ADDENDUM

NO. 1

PROJECT NAME: New Operations Building

PROJECT NUMBER: 1971-05-01

Job No.	Sheet No.
1971-05-01	A2.01
Drawn By: JT	
Date: 09/18/2025

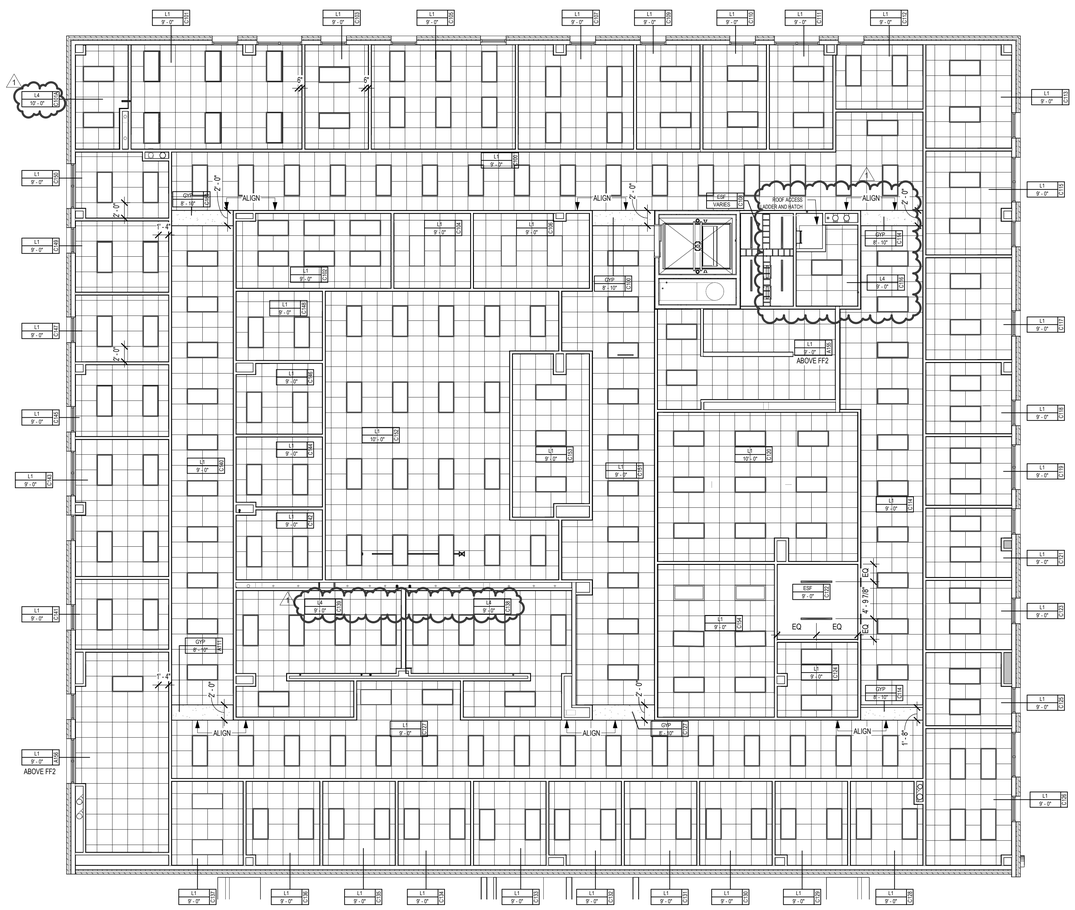
AD No 1, Arch. Item 41: To the Drawings, Sheet A2.01, "REFLECTED CEILING PLAN - LEVEL 1 & 2 - AREA A & C - OPERATIONS BUILDING,"
Refer to attached sheet for the following revisions:

1 REFLECTED CEILING PLAN - LEVEL 1 - AREA B - OPERATIONS BUILDING
1/8" = 1'-0"

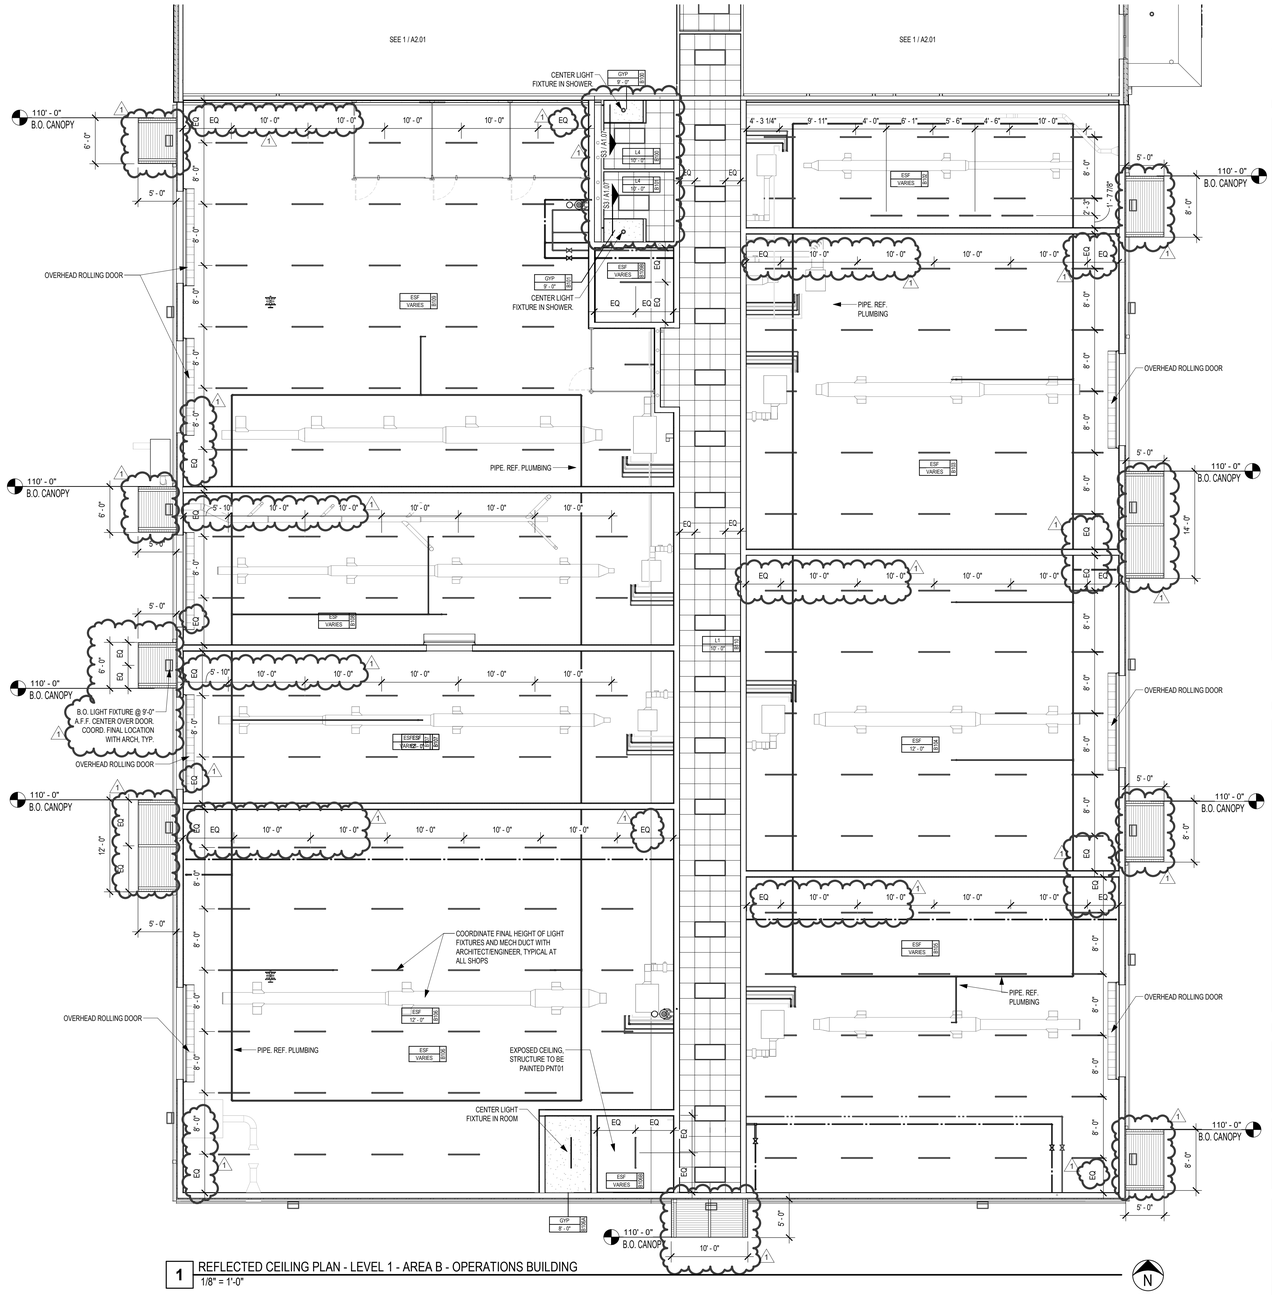
AD No 1, Arch. Item 42: To the Drawings, Sheet A2.02, "REFLECTED CEILING PLAN - LEVEL 1 - AREA B - OPERATIONS BUILDING,"
Refer to attached sheet for the following revisions:

1 REFLECTED CEILING PLAN - LEVEL 1 - AREA D - WAREHOUSE
1/8" = 1'-0"

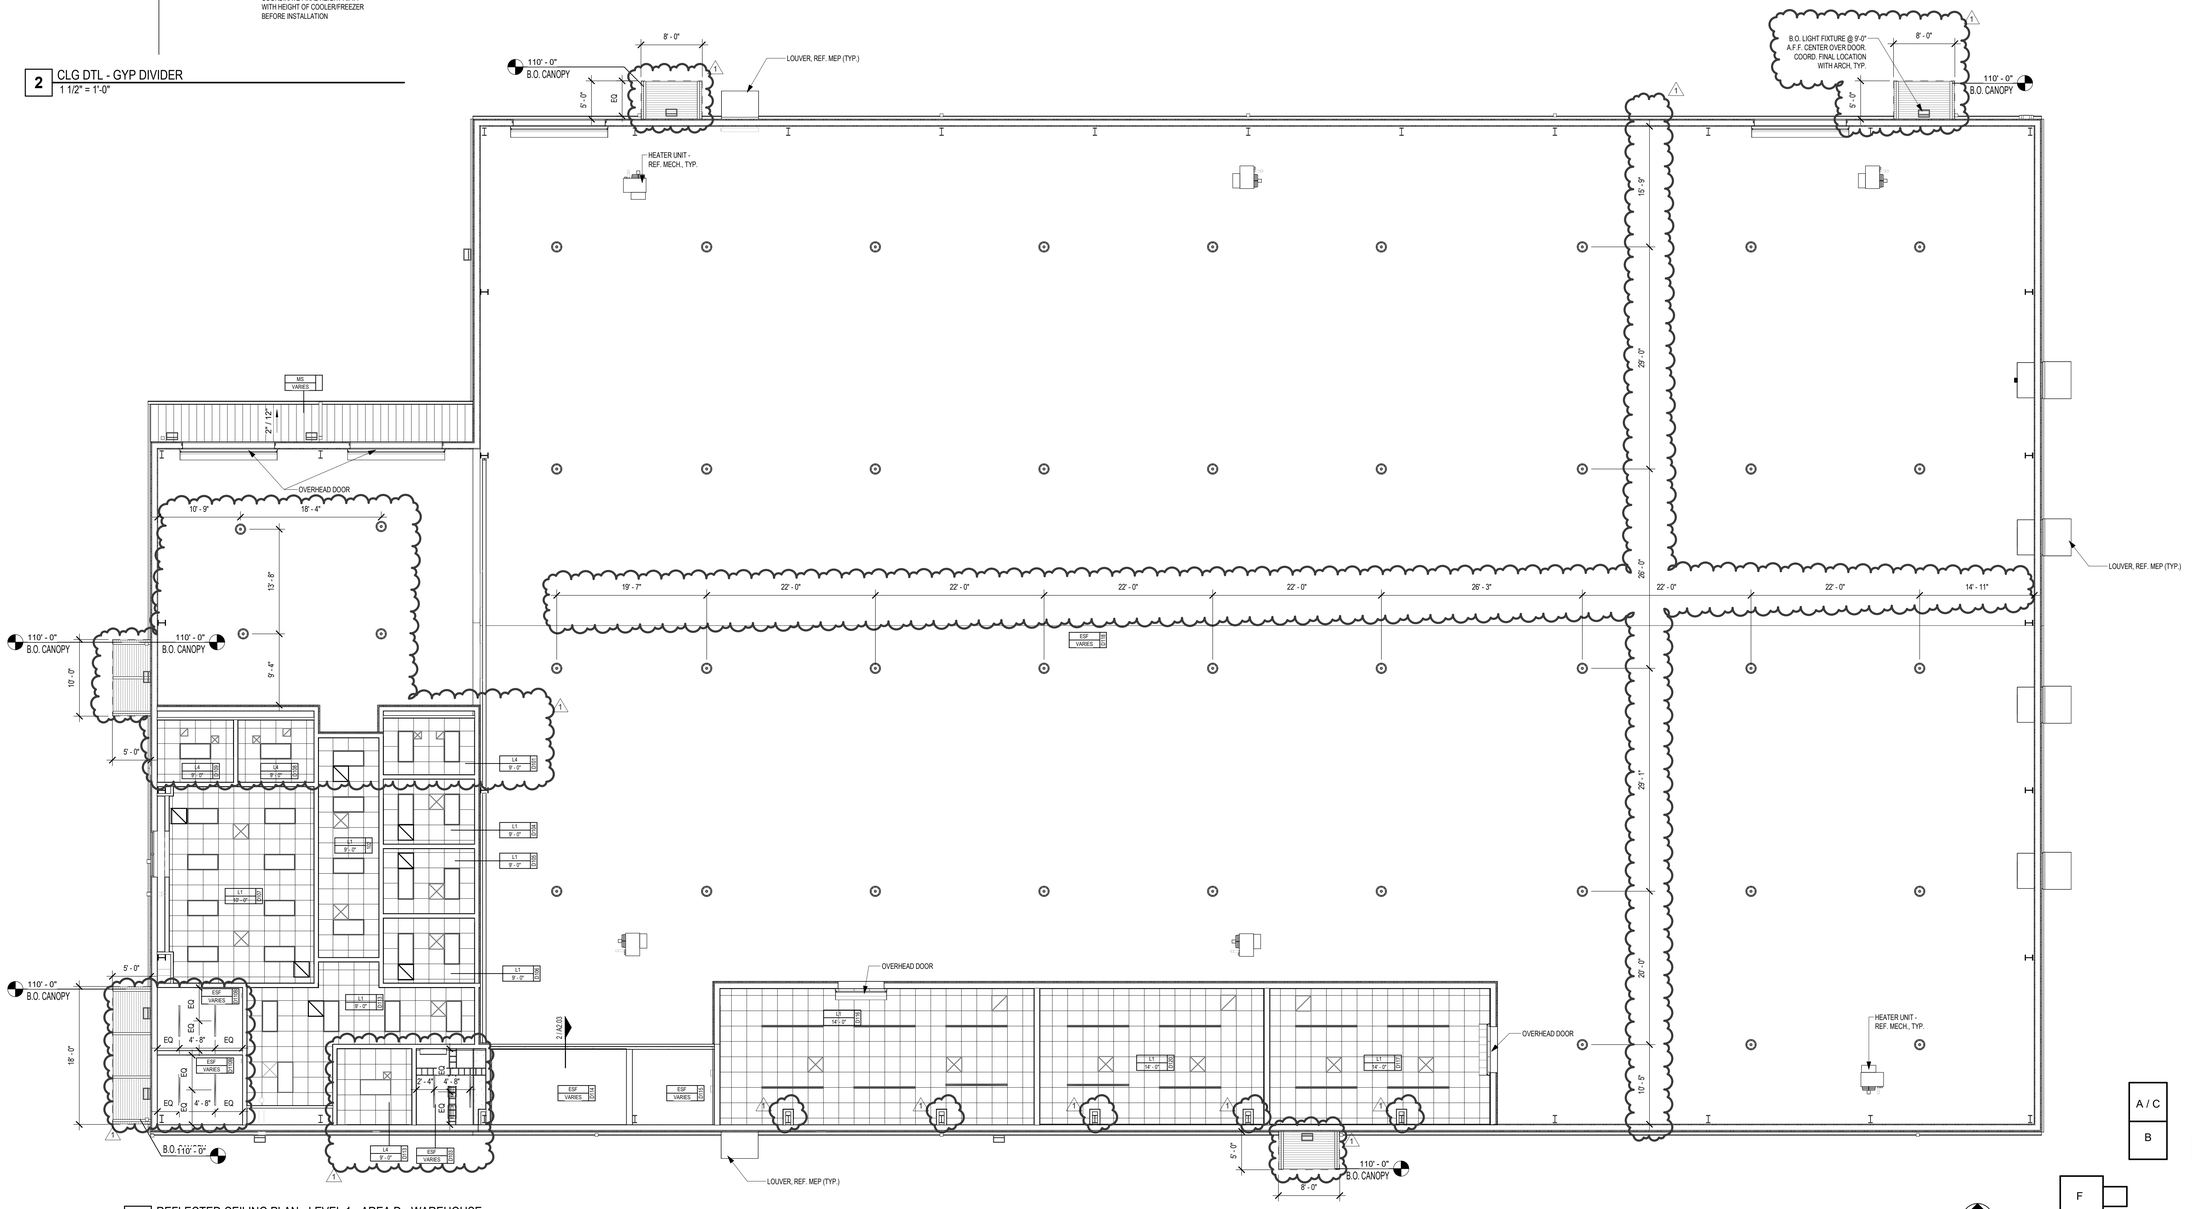
AD No 1, Arch. Item 43: To the Drawings, Sheet A2.03, "REFLECTED CEILING PLAN - LEVEL 1 - AREA D - WAREHOUSE,"
Refer to attached sheet for the following revisions:

Job No. 1971-05-01	Sheet No. A4.01
Drawn By: JT	
Date: 09/18/2025

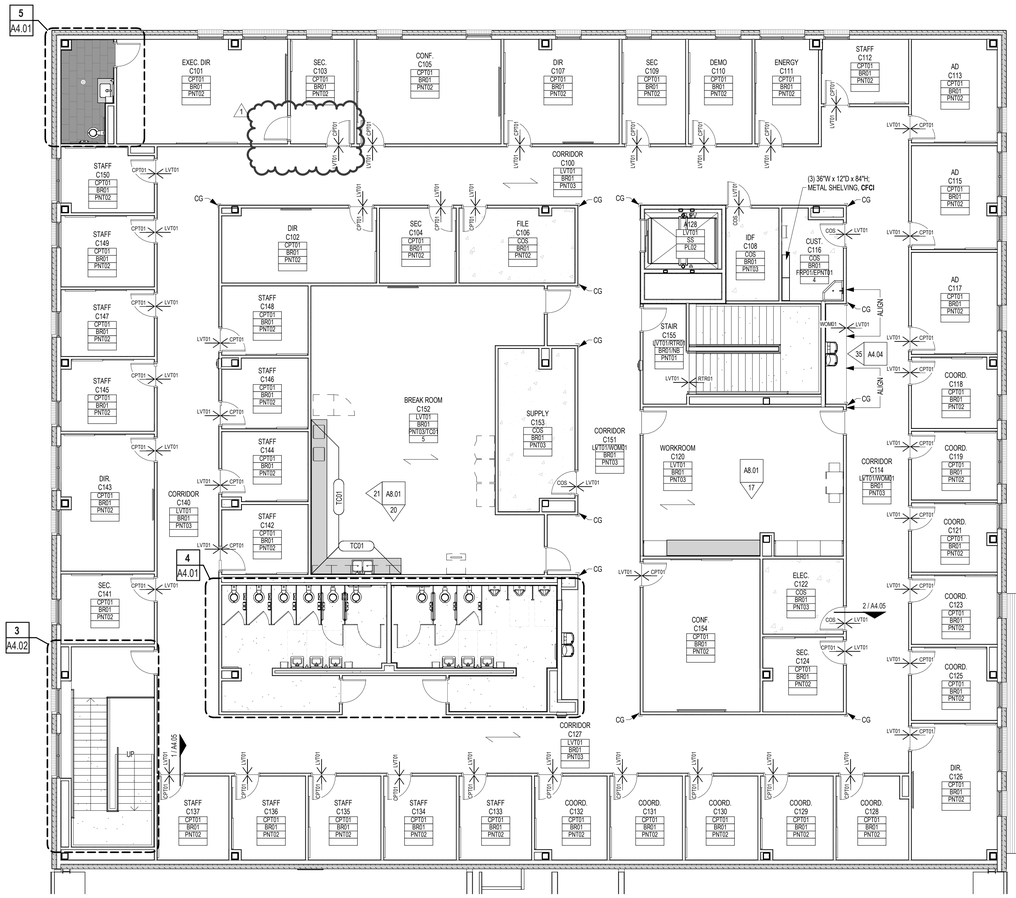
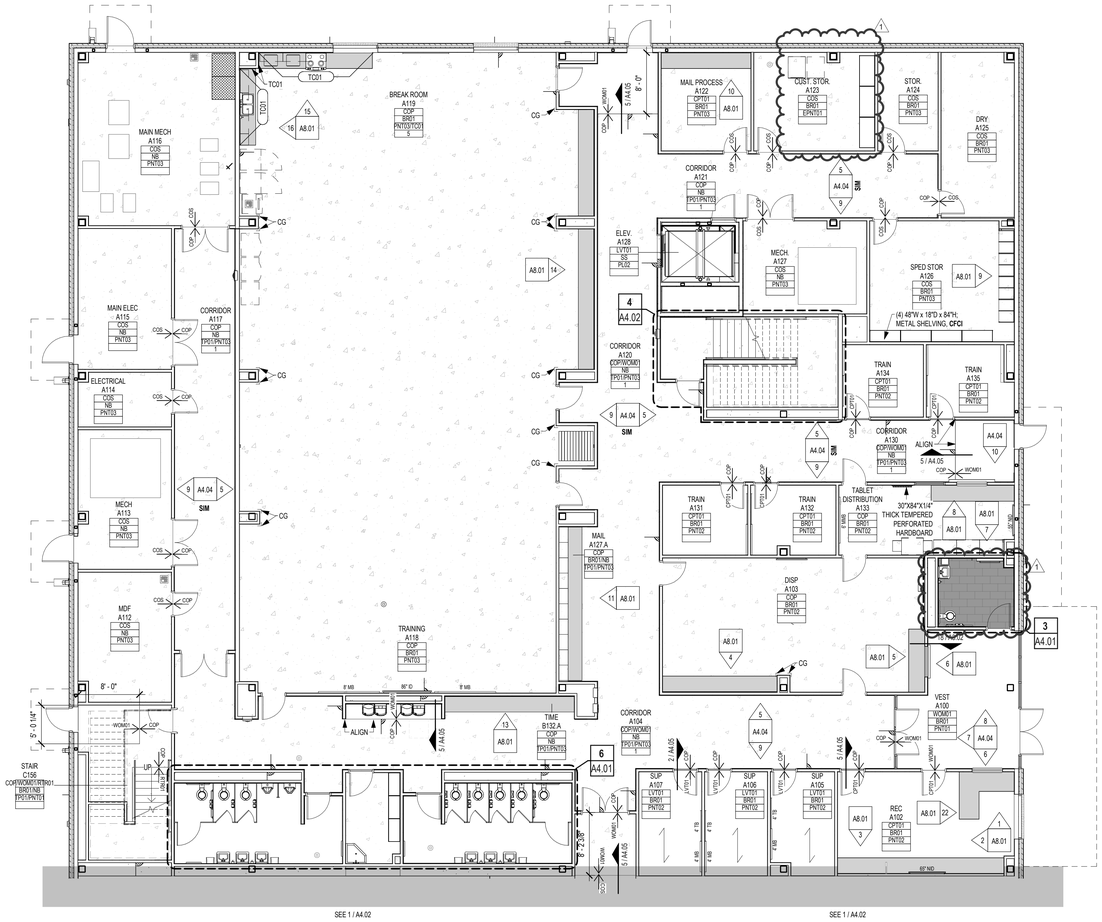
AD No 1, Arch. Item 45: To the Drawings, Sheet A4.01, "FINISH PLAN - LEVEL 1 & 2 - AREA A & C - OPERATIONS BUILDING,"

1 SIGNAGE PLAN - LEVEL 1 - AREA B - OPERATIONS BUILDING
1/8" = 1'-0"

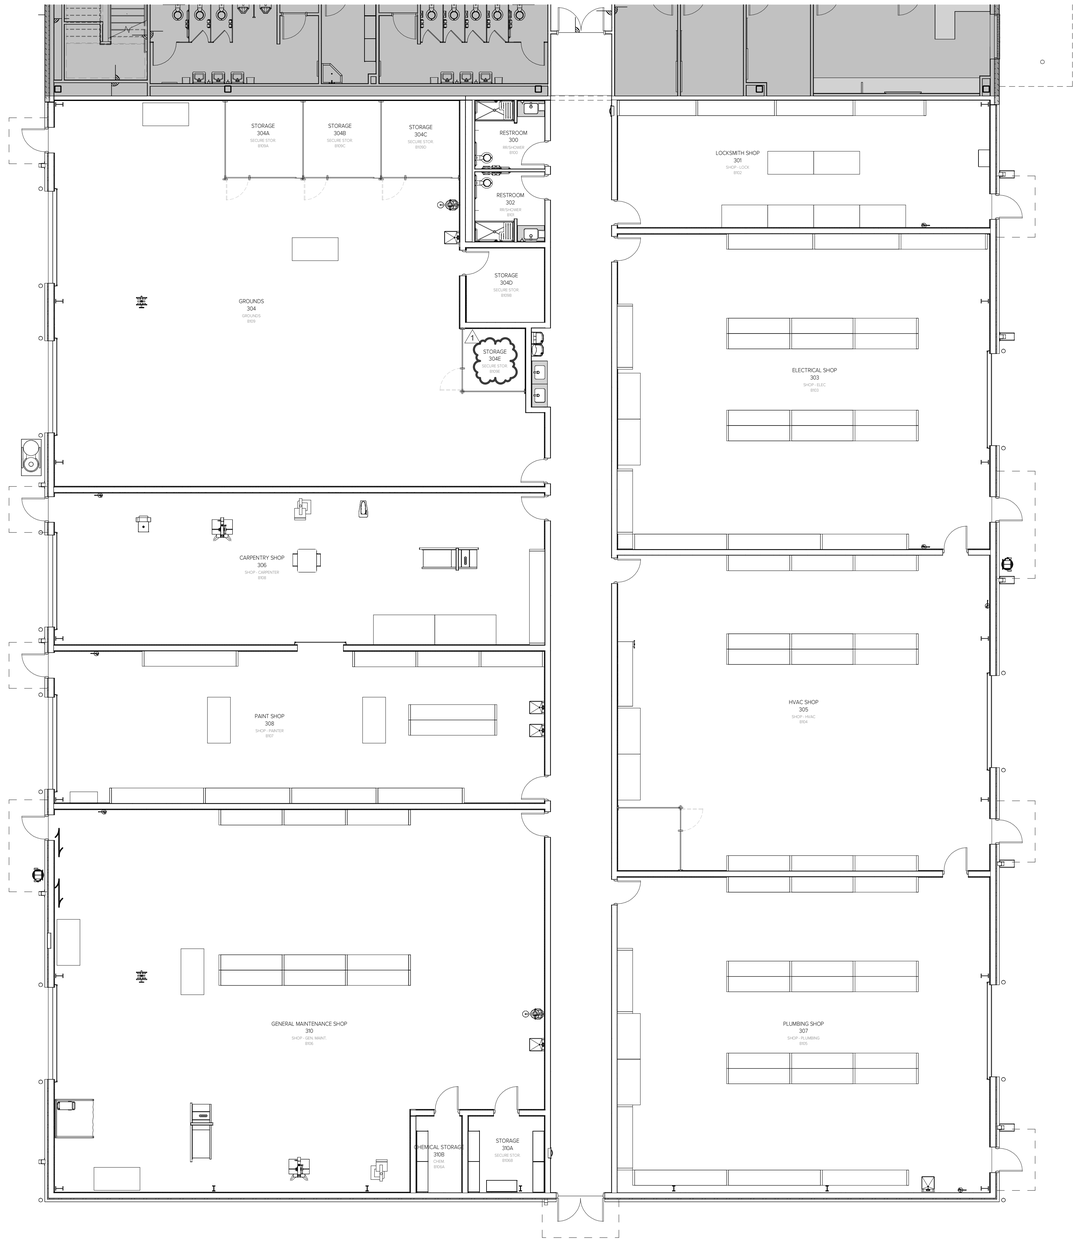
AD No 1, Arch. Item 46: To the Drawings, Sheet A4.07, "SIGNAGE PLAN - LEVEL 1 - AREA B - OPERATIONS BUILDING,"

Job No.	Sheet No.
1971-05-01	A8.02
Drawn By: JT	
Date: 09/18/2025

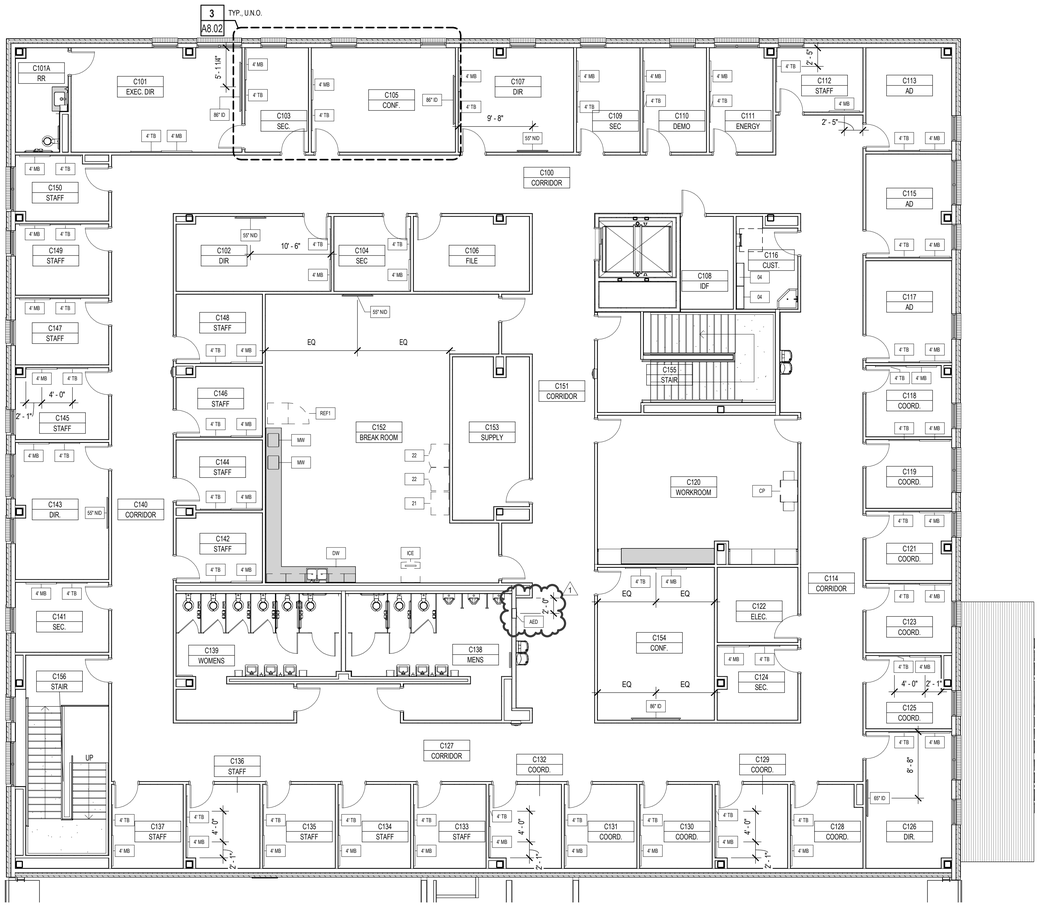
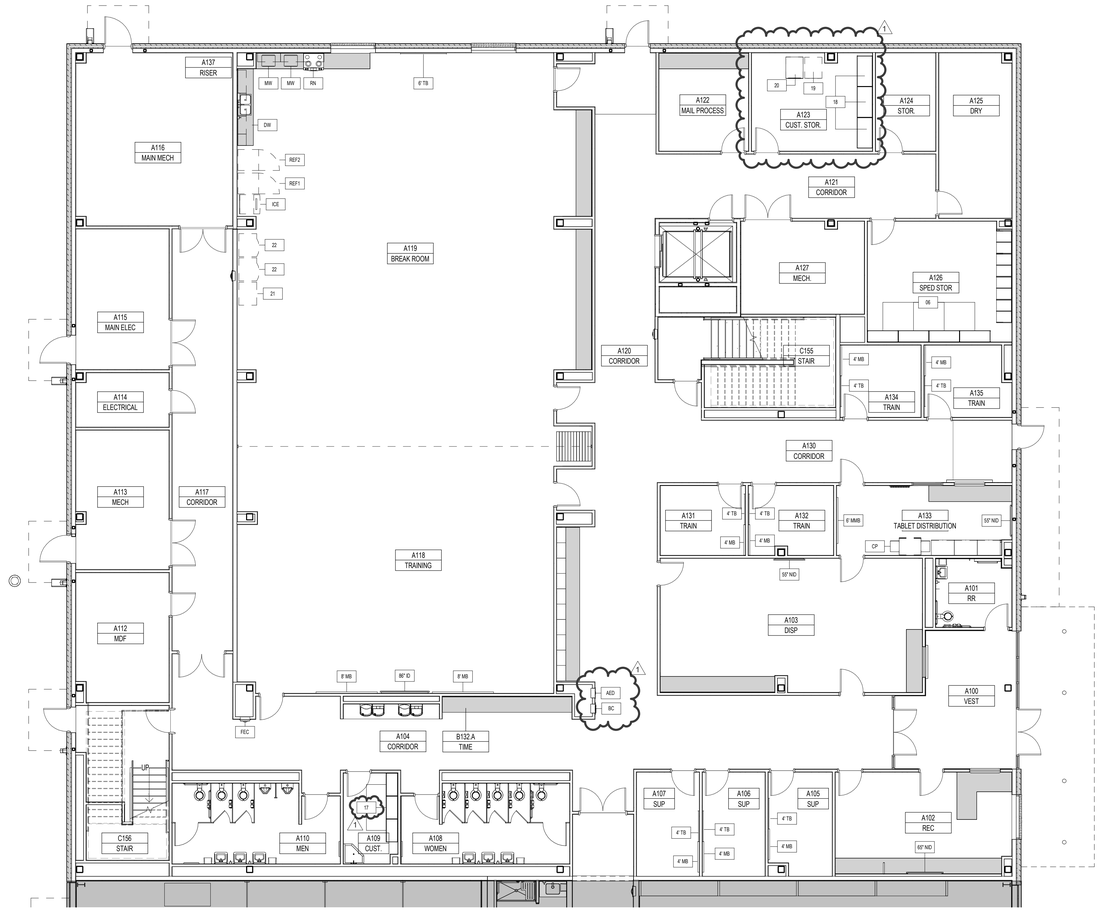
AD No 1, Arch. Item 48: To the Drawings, Sheet A8.02, "EQUIPMENT PLAN - LEVEL 1 & 2 - AREA A & C - OPERATIONS BUILDING,"
